TM 5000

# SERVICETEKNOTES

Published by Tektronix Service  
Administrative Support

S-3200 - SECURING INSTRUMENTS TO  
THE RACK

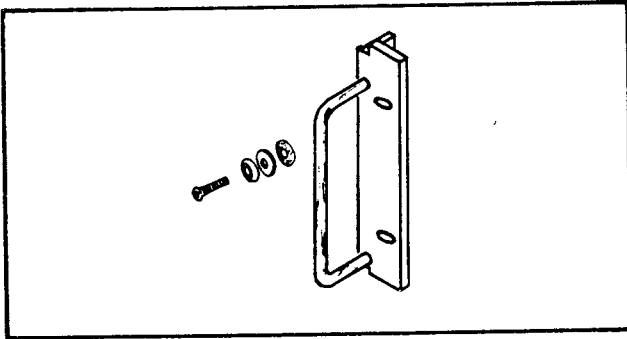
The screw and associated parts used to secure the different rack units to the rack are:

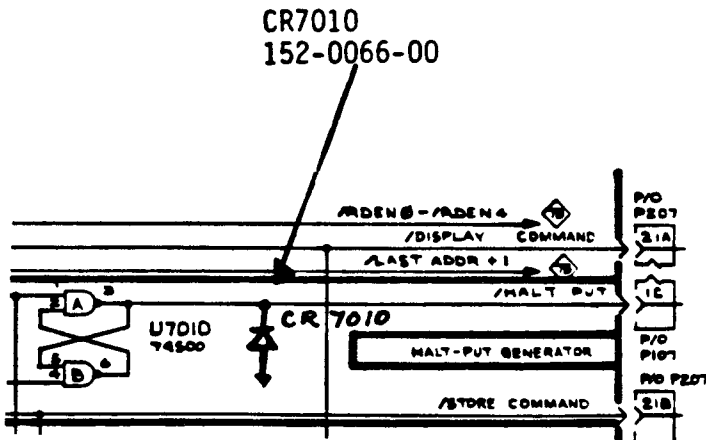
When inserting a personality module into a powered up 7D02 (hot plugging) it is possible to destroy or damage A07U7010. This will happen if the personality module is off center when hot plugged causing one of its conductors to short Pins 59 (-15 volts) and 61 (/halt put) of A01J8005. This effectively shorts the Pin 3 output of A07U7010 (/halt put) to the -15 volt supply.

To protect A07U7010 Mod #M46091 was implemented at Serial Number B021911. It places a protection diode, CR7010, 152-0066-00, between U7010-3 and ground (see included partial schematic 7A).

This diode should be added on the back of A07 with its anode soldered to U7010 Pin 7 and its cathode to U7010 Pin 3.

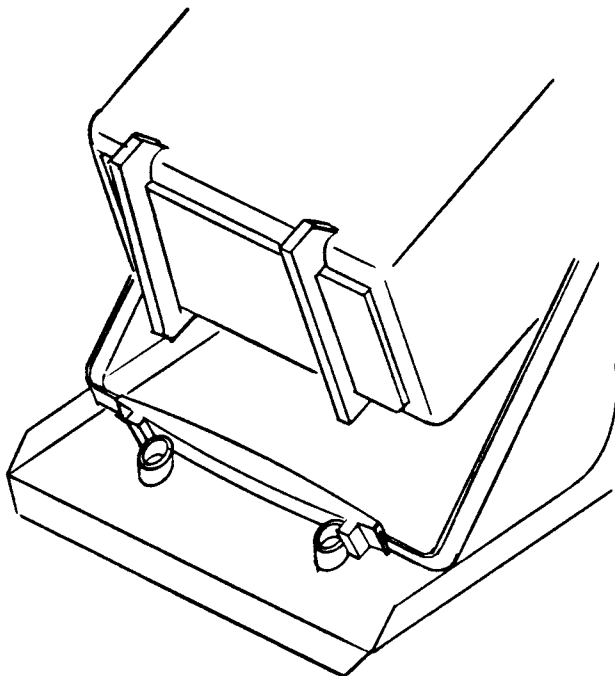
- because of the short instrument height represented by the 2335, 2336, and 2337 and non-compatibility of the instrument bottom feet/the 200C top tray retaining feet plus the mismatch of instrument height relative to the 200C tie-down strap:

We recommend the following procedure:

- 1st - position the articulated instrument handle underneath and to the most rearward, locked position.

- 2nd - open the instrument flip-down cover to the fully open and locked position.
- 3rd - position the cushioned portion of the instrument handle against the 200C top tray, rear retaining feet (refer to sketch).
- 4th - and finally, secure the instrument by cinching down the tie-down strap over the instrument.

Figure 3

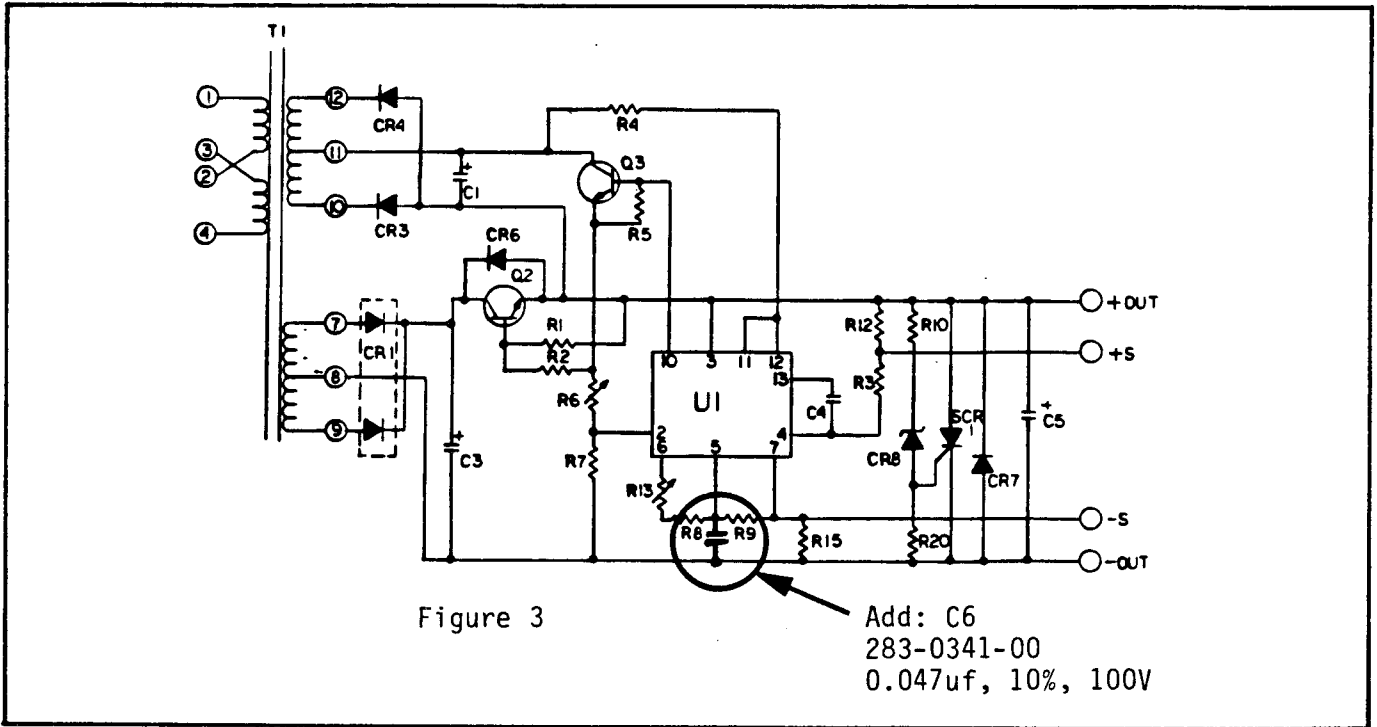
1800 PRAM -2V PWR SUP OSCILLATIONS, MOD NO. M50427

Add: C6  
 283-0341-00  
 0.047uf, 10%, 100V

1804 VOLUME 2 MANUAL CORRECTION, FIGURE 5  
REAR

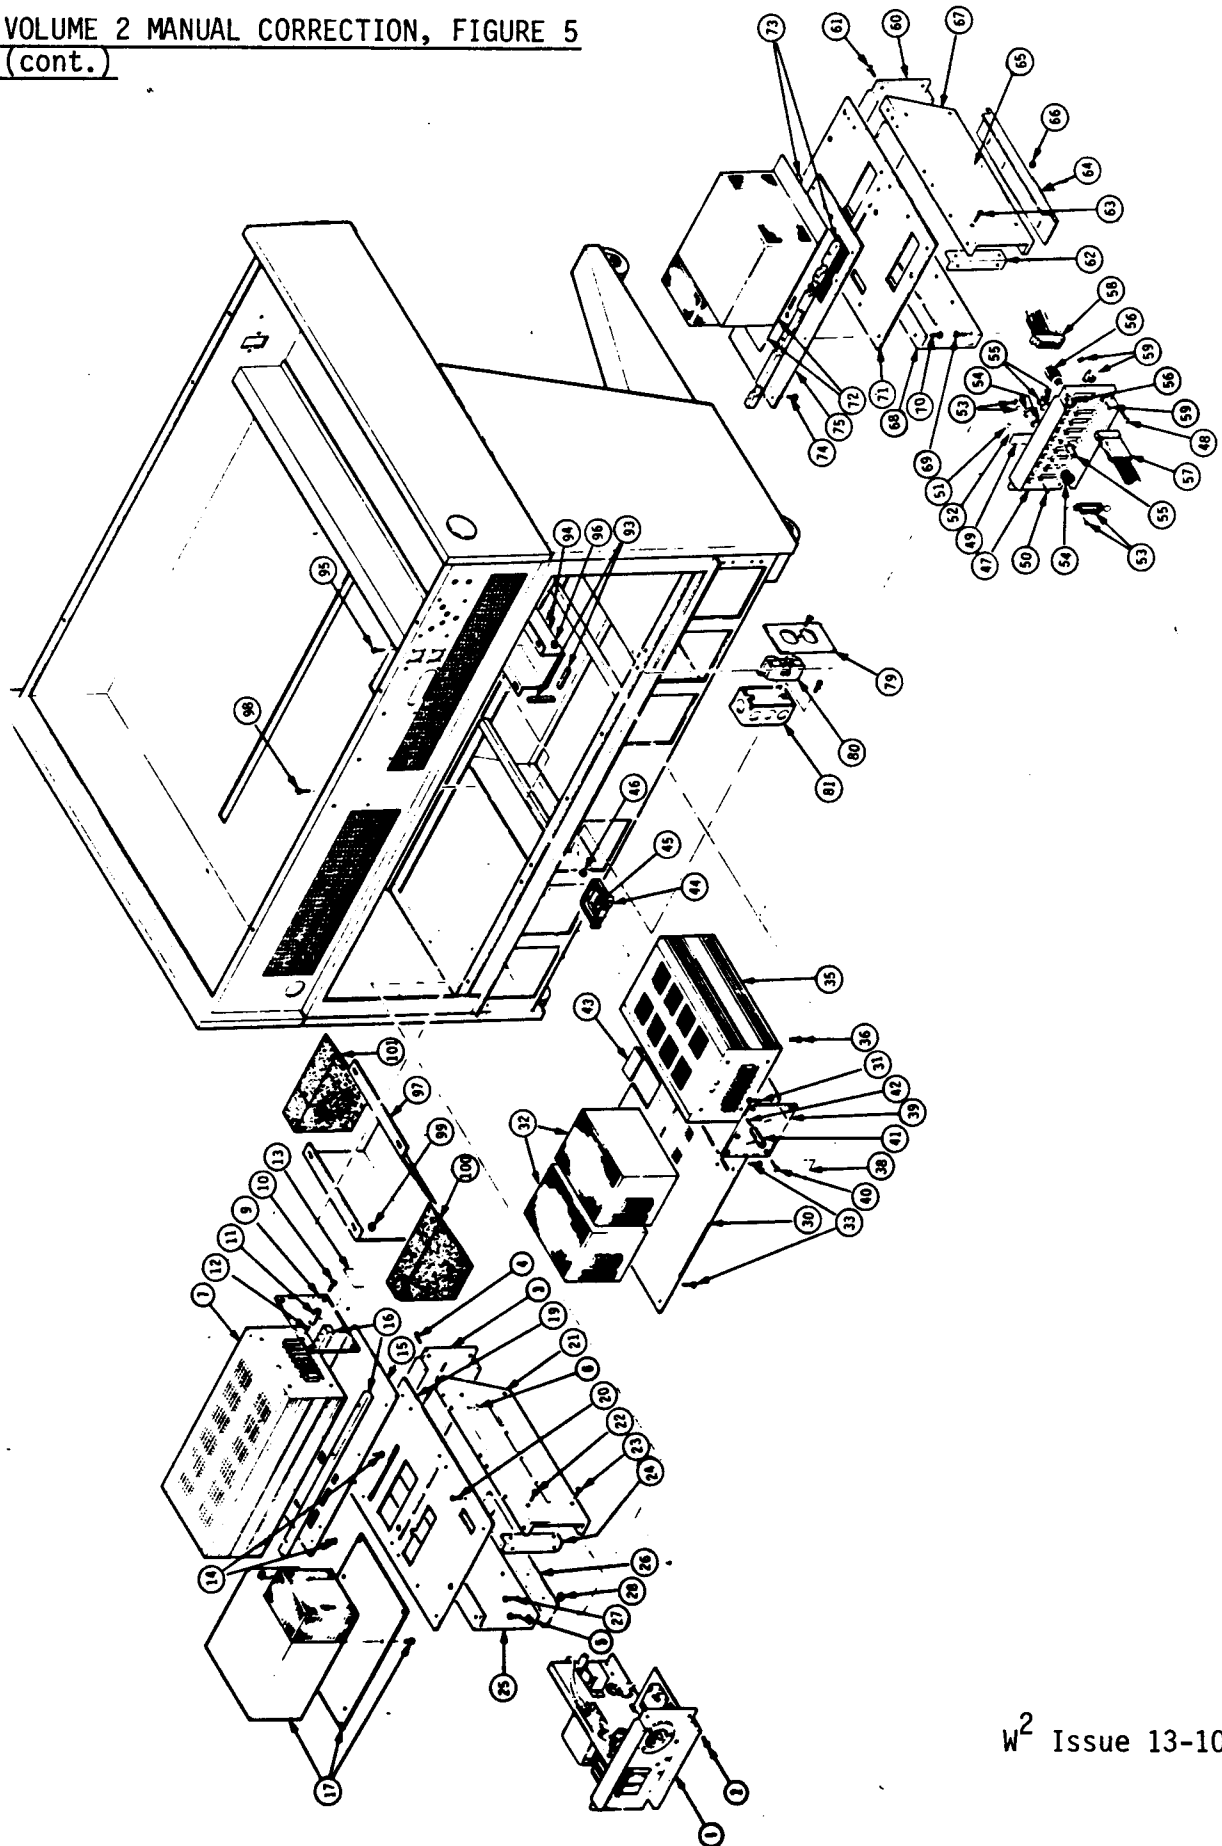
The index numbers in the mechanical view, Figure 5 Rear, do not match the replaceable Mechanical Parts List on pages 6-99 through 6-103. Attached is a mechanical view, Figure 1, which contains the correct index item numbers. Index numbers 8, 13, 18, 24.1, 24.2, 29, 34, 37, 76, 77, 82, 83, 84, 85, 86, 87, 88, 89, 90, and 91 are listed in the replaceable parts list, but are not shown in Figure 5.

The part number listed for index number 5-54 is incorrect. It should be 131-1011-00. For reference purposes only, one should add a note that the mating connector is P/N 131-1012-00 (not shown).

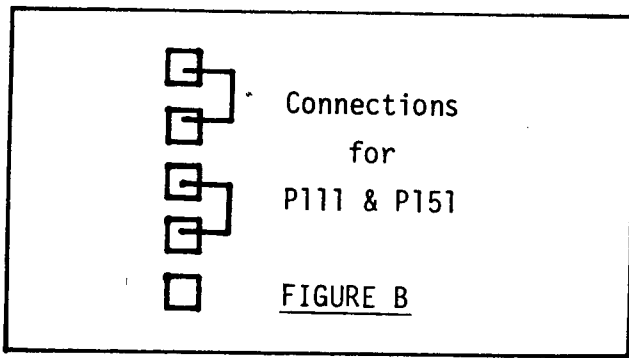
The suggested placement for these parts is in the Opt. 2 ROM/PROM board, A38, 672-1050-00, using the sockets labeled U111 for 160-1668-00 and U151 for 160-1669-00 (see Figure A).

Figure B illustrates the proper connections of P111 and P151 for these parts. Table 1 gives the SYSTEST FIRM listing that will result from the installation of this kit. Table 2 gives the Directory listing of the files that will be present with this kit.

FIGURE A

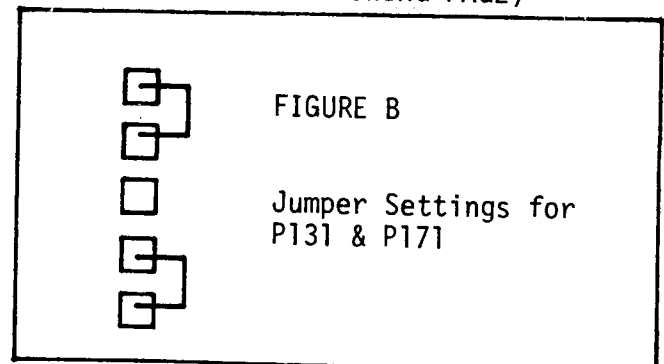
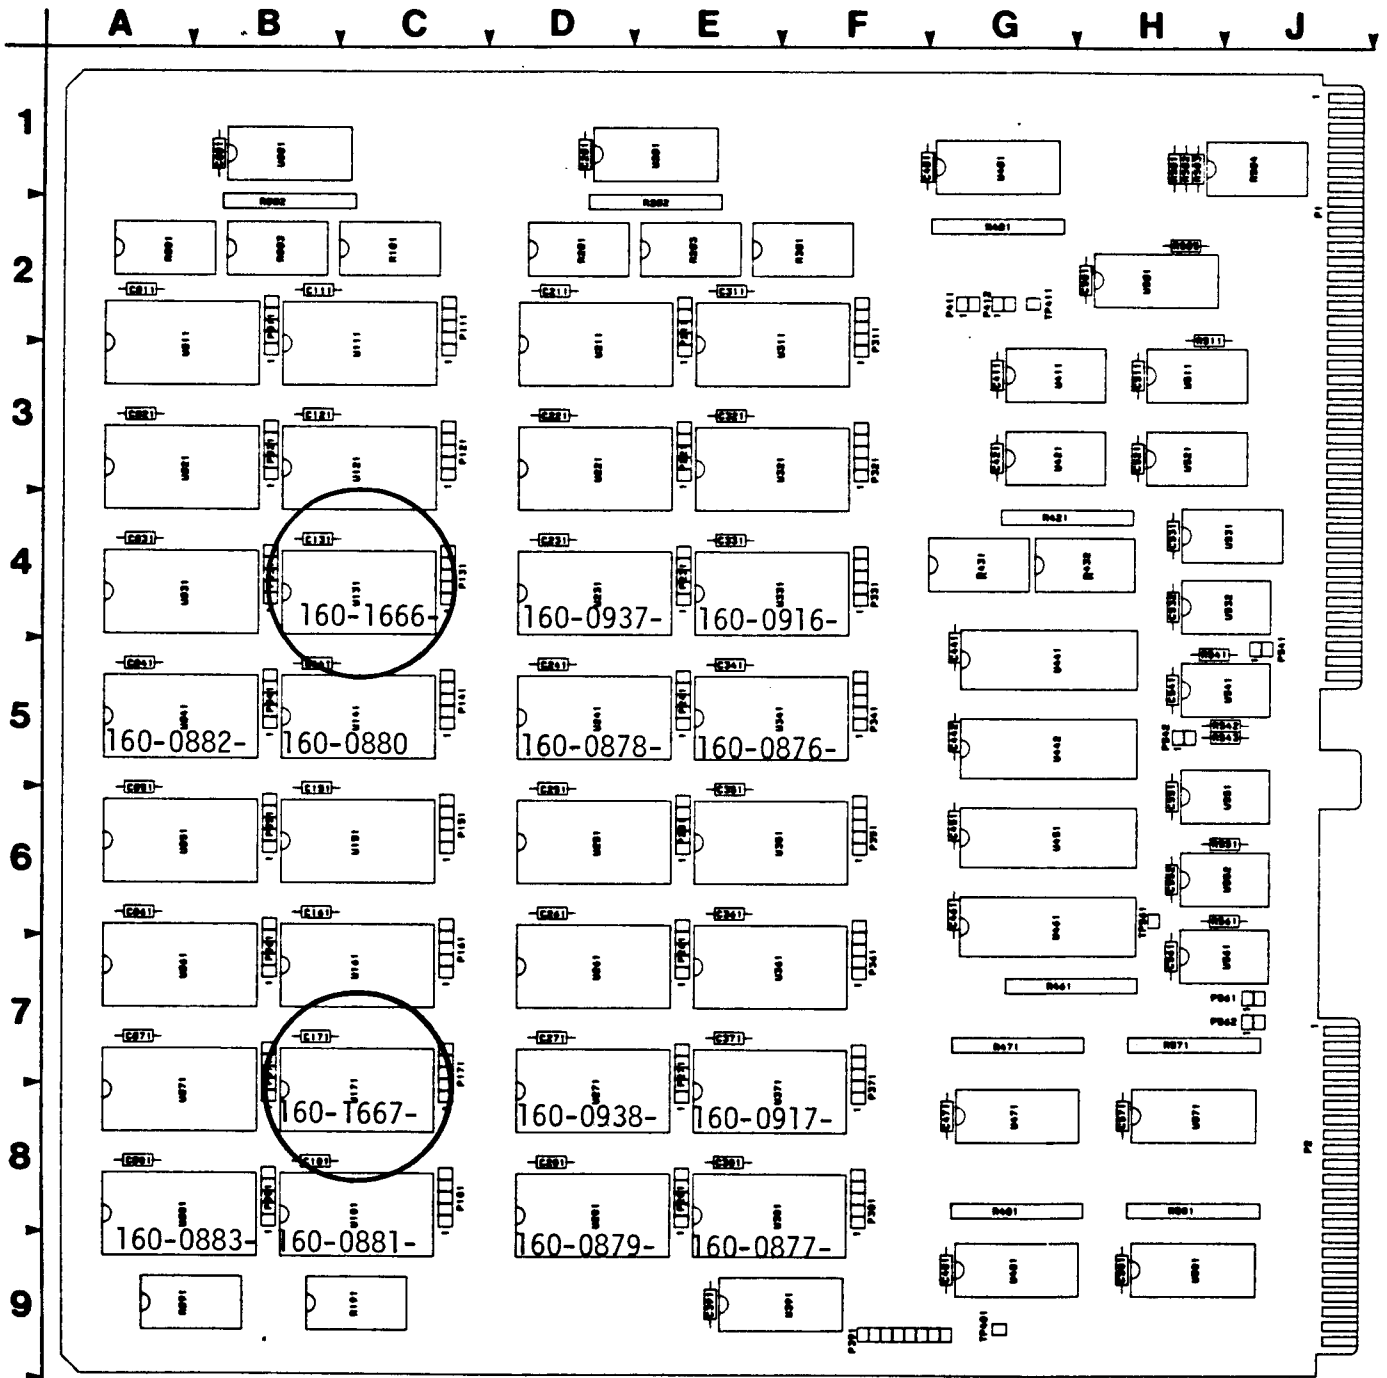
The suggested installation for these parts is to put them into the ROM/PROM NTSC Assembly B board, A36, 672-0939-00. Put P/N 160-1666-00 in the socket for U131 and P/N 160-1667-00 in the socket for U171. Figure A illustrates the configuration of 672-0939-00 with these two new parts installed. Figure B illustrates the required jumper settings for P131 and P171 when these parts are installed.

NOTE--The outlined areas in Figure A and Tables 2 & 3 show how the hardware and firmware will differ from the standard instrument.
